A A Butler, Cherry Trees, Cranford Drive, Hurst, READING, RG10 0ET
15/04/2026

Ref: WBC email Date: 13 April 2026, Development Management & Compliance

Revised Plans Consultation Application Number: 253074

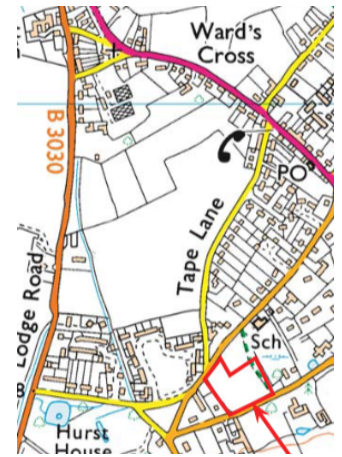
Pictured (right looking north and south) is deep surface water flooding in Tape Lane in April 2023 affecting safe access to Tape Lane/Barker Court. Not indicated on the Applicant's resubmitted Flood Exceedance Plan, this is a lower nearby location where surface water displaced from

the proposed Willowmead development will quickly end up. The only way this flooding can disperse is by infiltration or leaking into foul sewer manhole covers such as the one in the foreground – possibly 6701 at 38.38m AOD (if not

6701 will be nearby). From there any surface water leaking into the sewer will drain by gravity to Sawpit sub-pumping station to be pumped back up via Lodge Road towards the main A321 sewer and Hogmoor Lane (in the distance left photo) together with normal foul sewage and pumped leachate from Hurst Landfill.

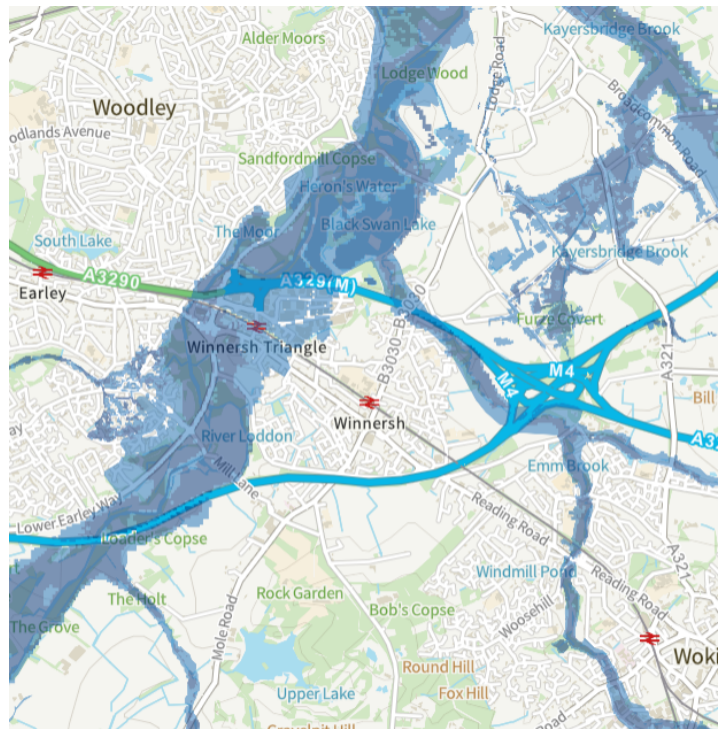
The wet day reservoir flood risk map shows flooding impinging on Hurst from the west through the “Sandford Gap” via Lea farm and from the north via Whistley Green impacting the 5SU030 site from the northwest. **There is quite a lot for WBC to check here:**

Is the flood risk correct, has too small a volume been used to assess the black Swan Lake risk?

Does not the SFRA 5SU030 text need to be altered as the stoplog weir at the northeast of Black Swan Lake is clearly a lot nearer Hurst than Bearwood?

Interestingly the islands and features around Black Swan Lake, including the embankment path 2m above the Emm Brook correctly stand proud above the surface on this map – which they don't on the GOV.UK rivers and sea flood zone map where the whole area is incorrectly shown flooded (indicating incorrect base topographical data is being used). See screenshot below, Black Swan Lake is already flooded above the zone 3 flood level; even if the adjacent Emm Brook and surrounding land is flooded to a depth of 1m the embanked surrounding features will still be 1m above the flooding. The GOV.UK flood map for planning also shows the relative locations of South Lake and Bearwood (Upper Lake) reservoirs. The absurd strip of flood zone 3 across the western landfill hill can also be seen on this screenshot.

The screenshot also indicates the pluvial surface water trapment triangle created by the destruction and building-up of flood plain west of Hurst. With the higher land of Haines Hill to the east and Ashridge to the south, the only way left for surface water to drain from Hurst is via what is labelled on the flood map as Kayersbridge Brook – better known in Hurst as The Green Man and Stowe streams.
